RANGELINE BUSINESS PARK SUBDIVISION, **UNIT TWO**

APPLICATION NUMBER 18 DATE February 4, 2010

REQUEST Subdivision

DETAIL SITE PLAN

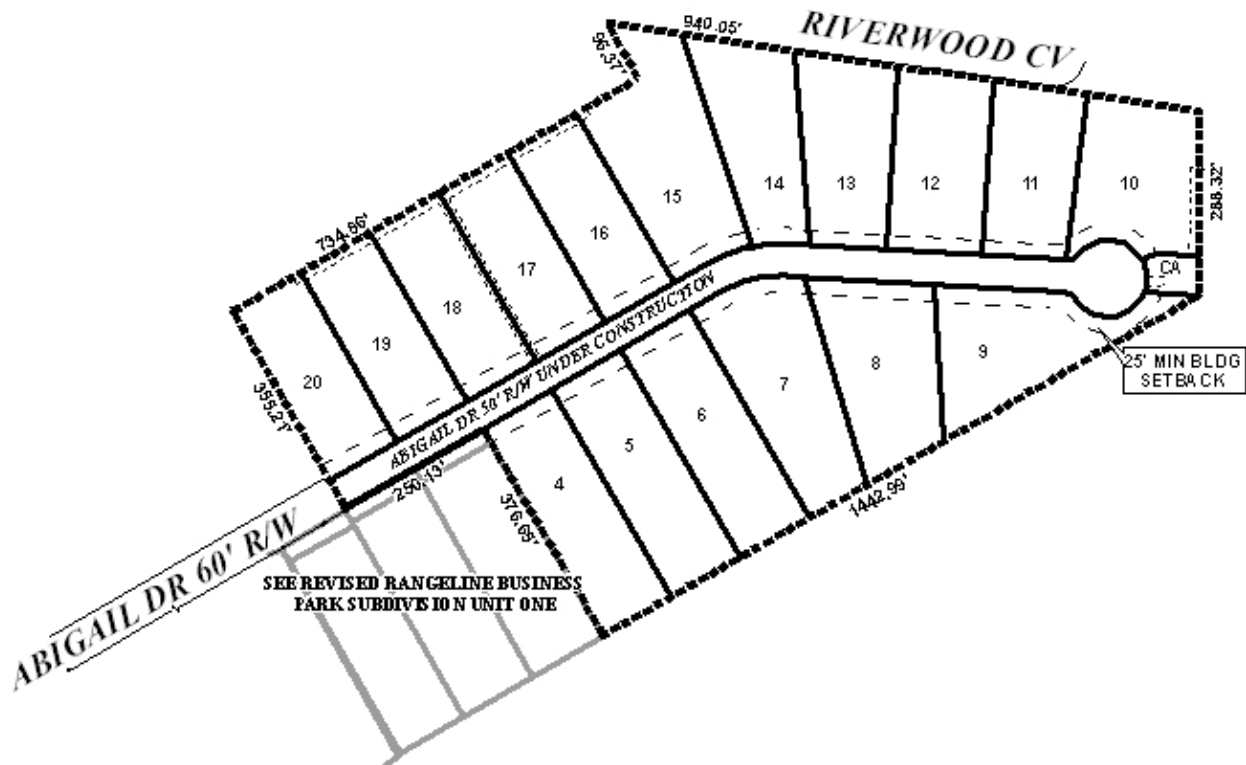
The proposed lots, as depicted, meet the minimum size and frontage requirements as regulated by the Subdivision Regulations. The areas of the lots are not depicted on the plat, and should be shown on the Final Plat in square feet, or a table provided on the Final Plat with the same information, if approved.

All of the lots are proposed to front Abigail Drive which is depicted as being under construction. Adequate right-of-way of 50 feet is depicted. Further, the turnaround at the end of Abigail Drive is depicted with a 60-foot radius, which is adequate to comply with Section V.B.14 of the

It should be noted that Abigail Drive is a closed-end street and, with this proposed extension, will be approximately 975-feet in length. The maximum length for a closed-end street, as per Section V.B.6 of the Subdivision Regulations, is 600 feet. As the commission has previously approved a subdivision in this same area, which proposed Abigail Drive to be the same length, and the fact that this site abuts platted properties to the east, a waiver of Section V.B.6 may be appropriate.

The 25-foot minimum building setback line is depicted on the preliminary plat, and this should be retained on the final plat, if approved.

Due to the limited width of 16 of the 17 lots, all lots should be restricted to one curb-cut, with the exception of Lot 9, which should be limited to two curb-cuts, with the size, design, and exact location of all curb cuts to be approved by Traffic Engineering and conform to AASHTO standards.

All common areas and common detention facilities, if any, should be labeled as such, and a note placed on the Final Plat stating that the maintenance of said facilities is the responsibility of the property owners.

- 1) completion of Abigail Drive to City Standards, and acceptance of the same prior to the signing of the Final Plat;
- 2) depiction of the lot sizes, in square feet, or provision of a table on the Final Plat with the same information;

- 3) retention of the 25-foot minimum building setback line on the Final Plat;
- 4) placement of a note on the Final Plat stating that each lot is limited to one curb cut to Abigail Drive except Lot 9, which is limited to two curb cuts to Abigail Drive, with the size, design, and exact location of all curb cuts to be approved by Traffic Engineering and conform to AASHTO standards;

- 5) placement of a note on the Final Plat stating that maintenance of all common areas and common detention facilities is the responsibility of the property owners;
